# Service Bulletin

Bulletin No.: PIC5861

**Subject:** SES MIL DTC P0442

**Models:** 2010 - 2012 Buick LaCrosse  
Equipped with 3.0L (RPO LF1) or 3.6L (RPO LLT)

3436210

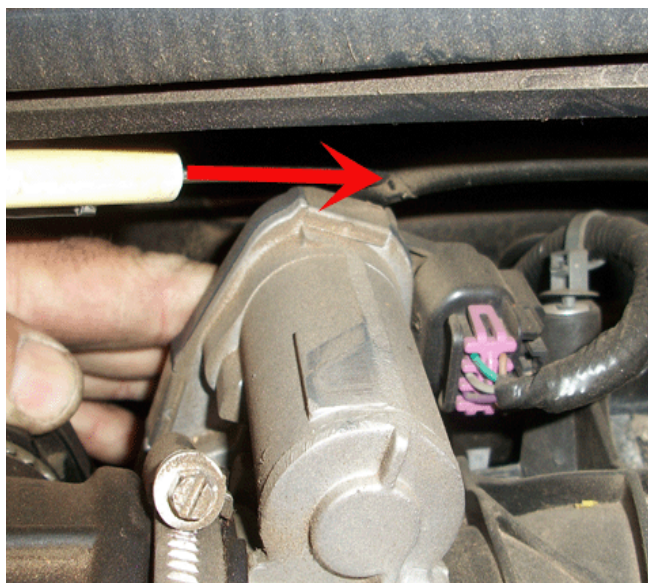
Visually inspect evaporative pipe for contact with the throttle body. If contact is present, replace the evaporative pipe as needed and secure to eliminate future contact. Clear DTCs.

**Note:** The new evaporative pipe will have a conduit installed in the area of concern of the original pipe. Reference photos below.
